CLERMONT COUNTY OHIO

PLANNING COMMISSION STAFF REPORT

COTTAGE GROVE – DESIGN PLAN

COTTAGE GROVE SUBDIVISION DESIGN PLAN

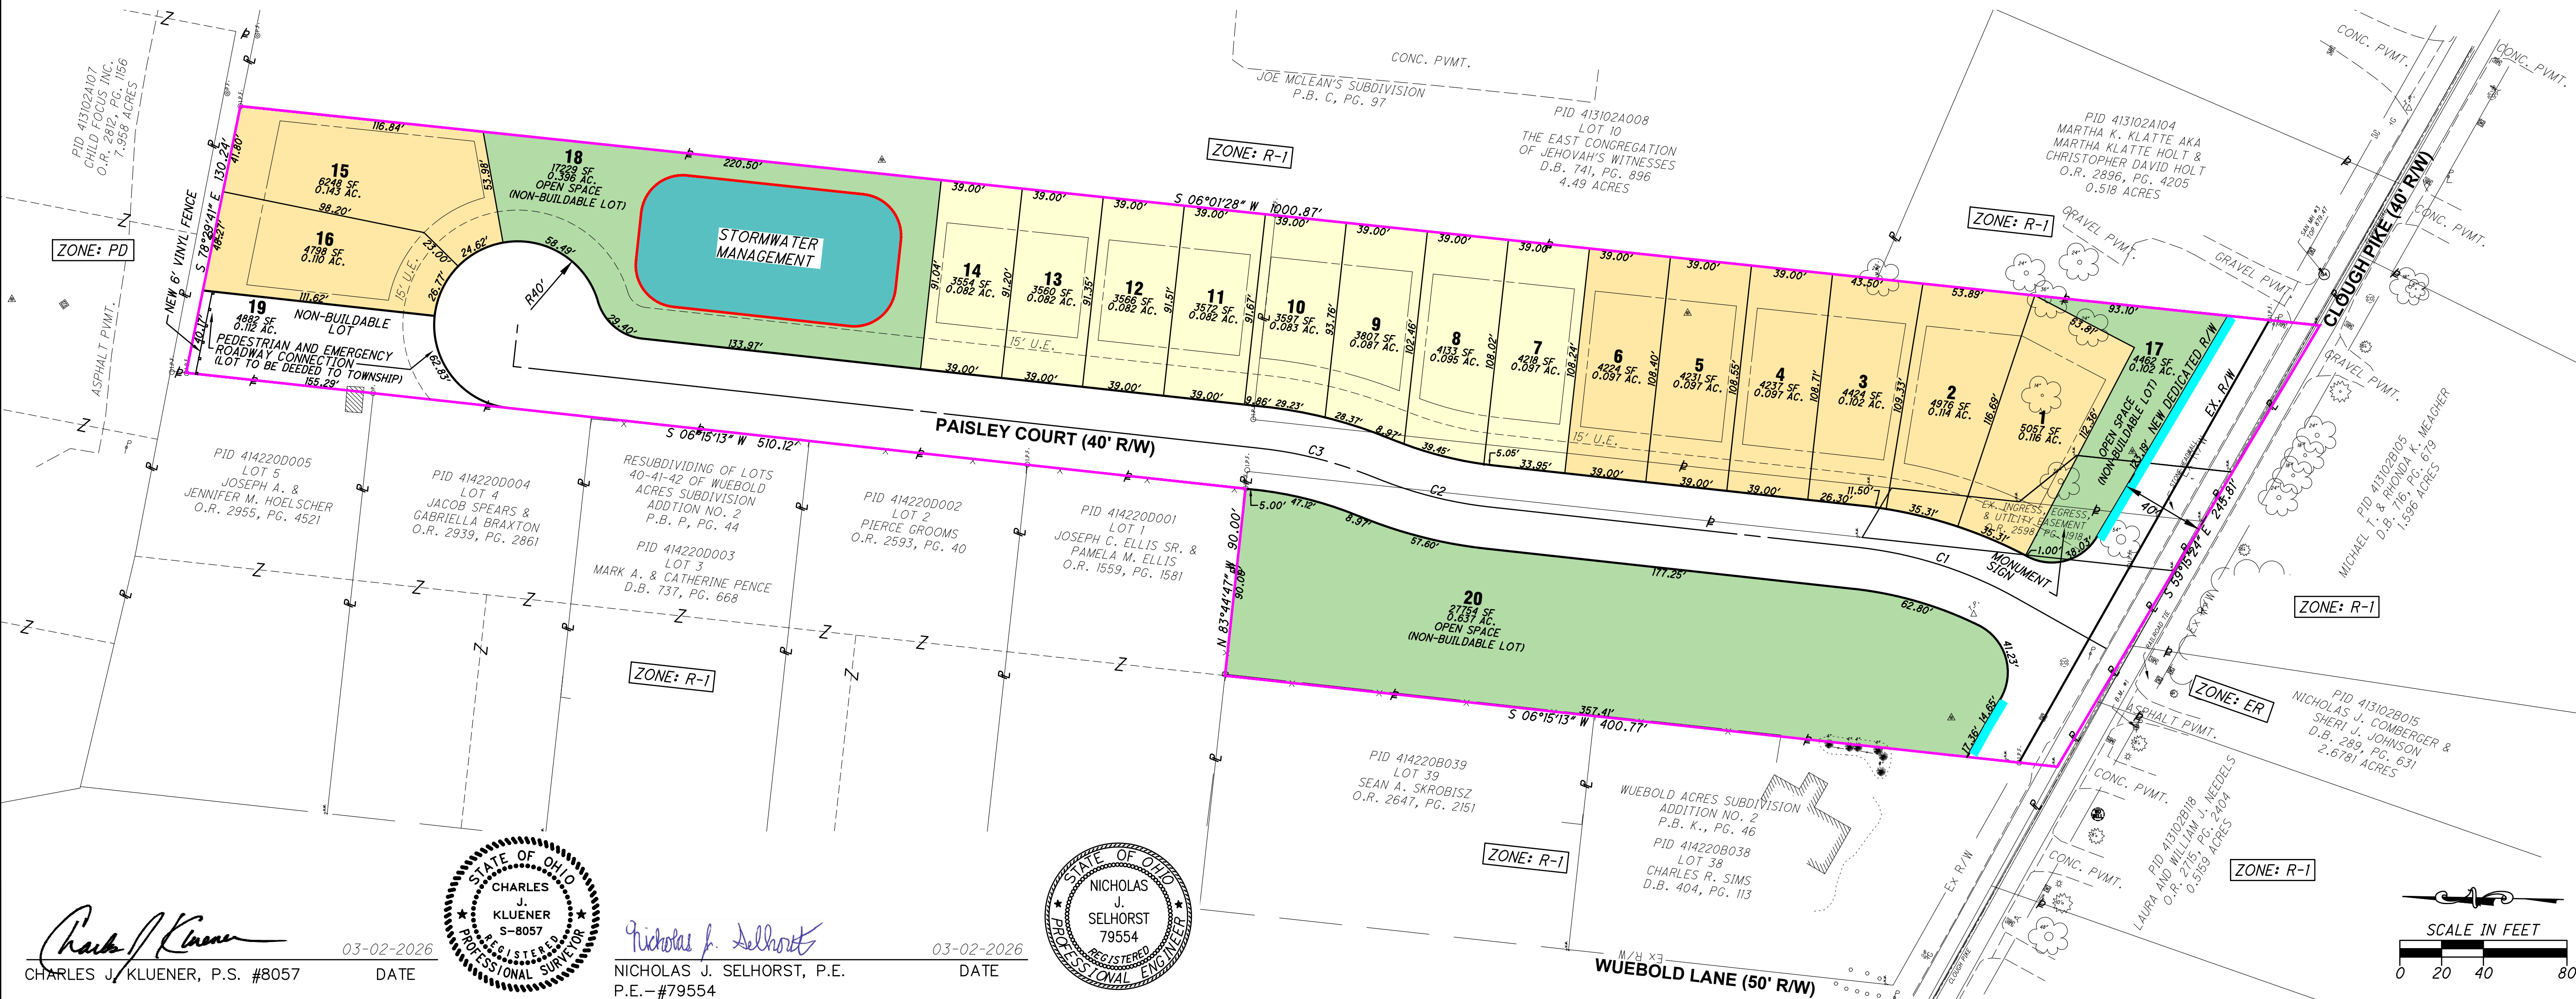
1. Note upon the plans who is to maintain the proposed stormwater management facility.
2. The width of the Paisley Court Right-of-Way needs to be adjusted. A fifty (50) foot right-of-way is the standard width for residential subdivisions.
3. The geometry of the proposed cul-de-sac needs to be adjusted. A minimum Right-of-way radius of 46 feet is to be used.

4. The width of the proposed road needs to be 28 feet, since the proposed development has a 23 foot front yard setback.
5. Lot numbers need to be adjusted to reflect a logical/sequential order.
6. The proposed sidewalk along Clough Pike needs to be located outside of the Right-of-Way.
7. The proposed streetlight near the North property line for Lot 18 needs to be adjusted. The street light needs to be located outside of the Cul-de-Sac.
8. Curb Ramp need to be provided at all end of the sidewalks.
9. A general reminder regarding roadway geometry; the minimum allowable street grade is 0.4%, maximum street grade is 12% (10% preferred), and the minimum centerline curve radius is 200' (two hundred feet).

COTTAGE GROVE
UNION TOWNSHIP, CLERMONT COUNTY
UTILITY LAYOUT

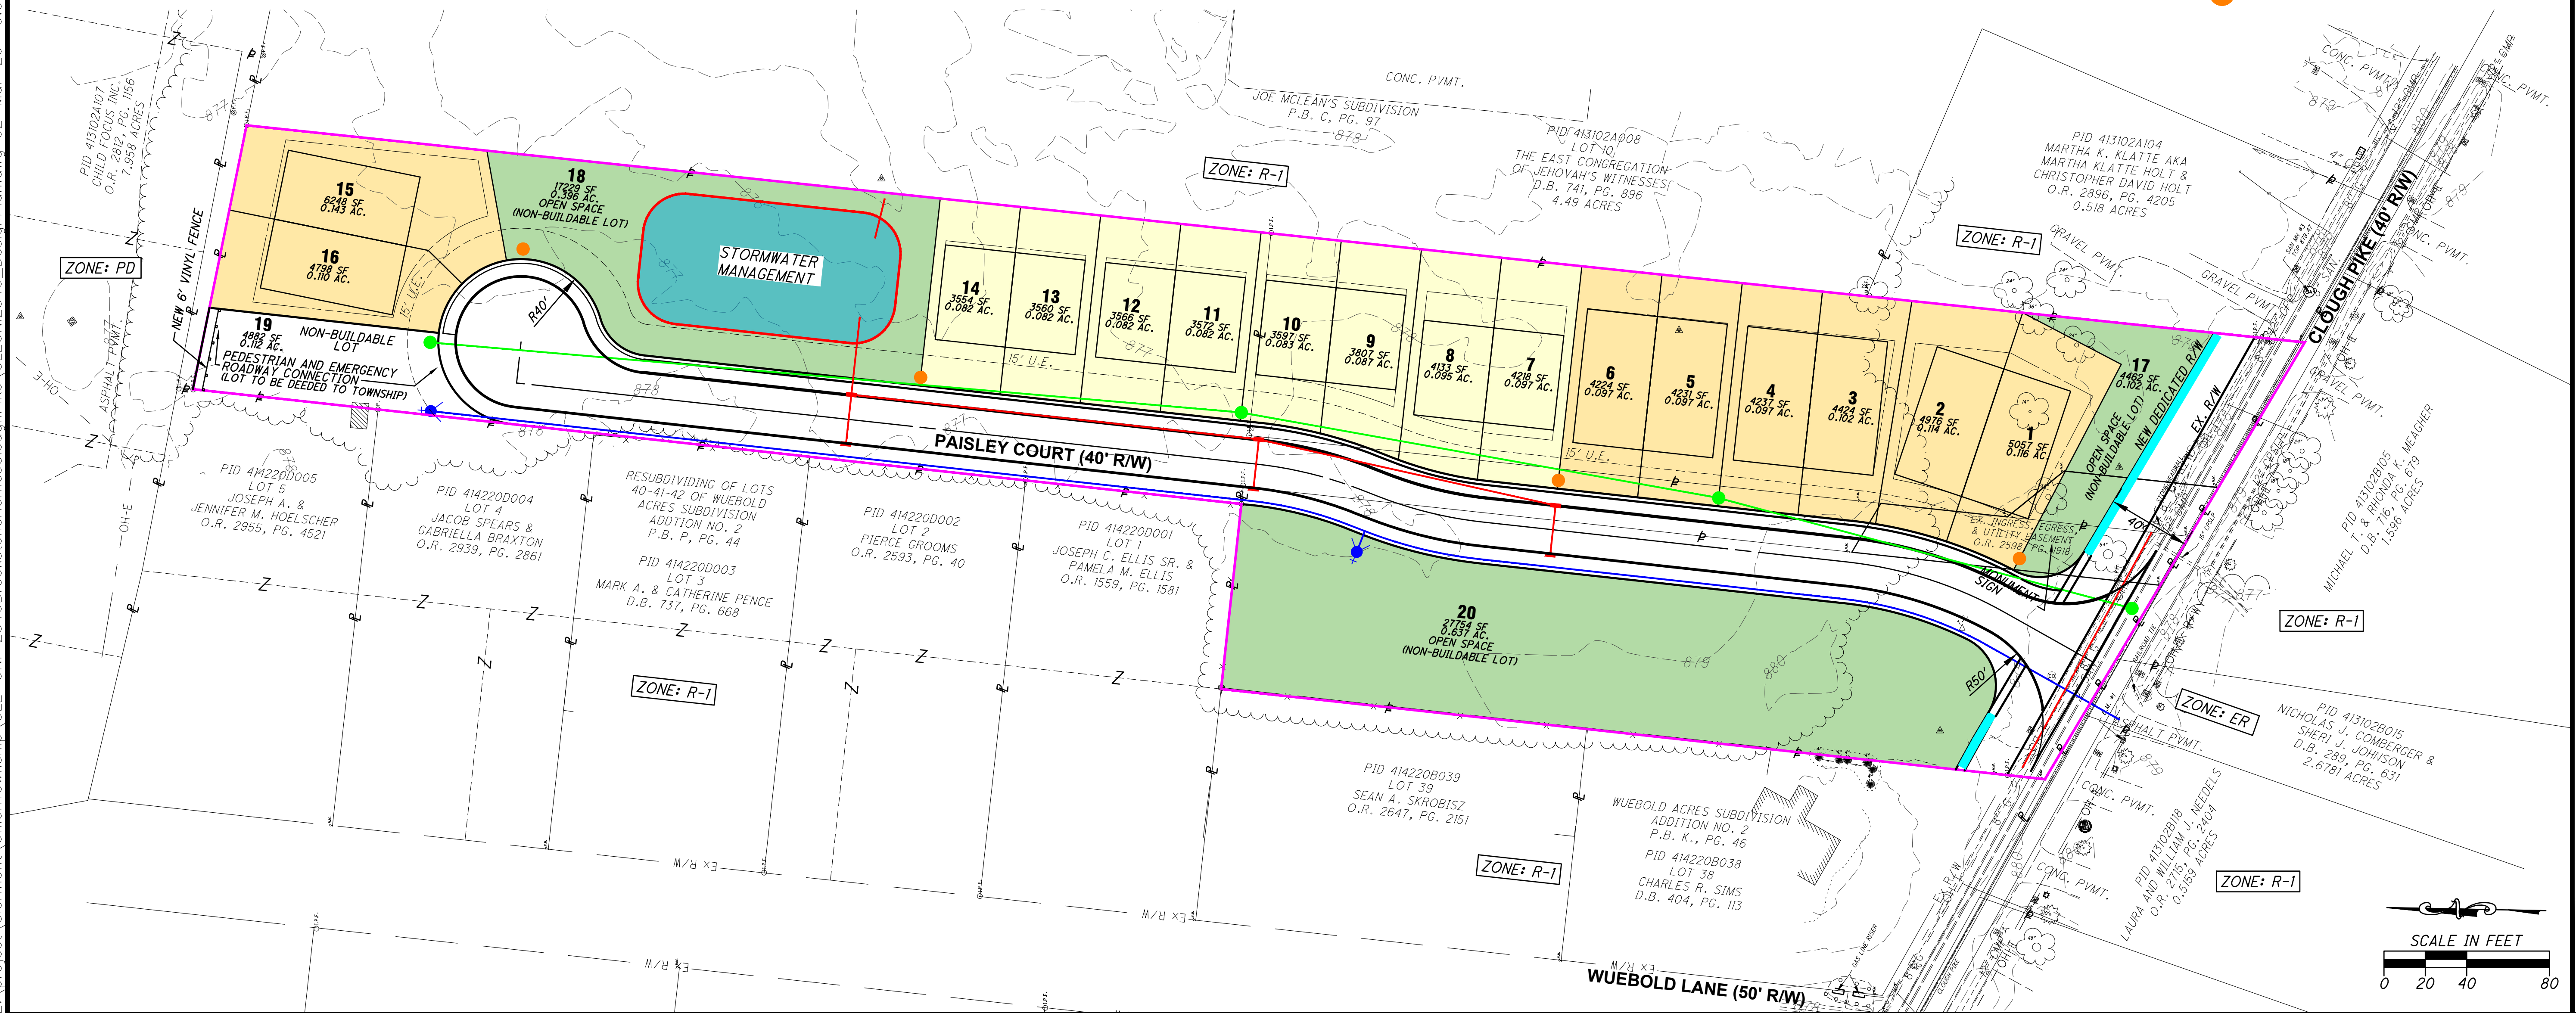
1. On Sheet 2, The watermain is shown along the property line. Please show the appropriate easement width that accommodates the watermain.
2. On Sheet 2, The fire hydrants outside of the R/W require a 15x15 foot easement centered on the fire hydrant per CCWRD standards.
3. On Sheet 2, The fire hydrant at the cul-de-sac needs to point toward the center of the cul-de-sac.
4. On Sheet 2, where the water and sanitary sewer leave the R/W and public utility easement, the utility will need to be covered with the appropriate easement according to CCWRD standards.
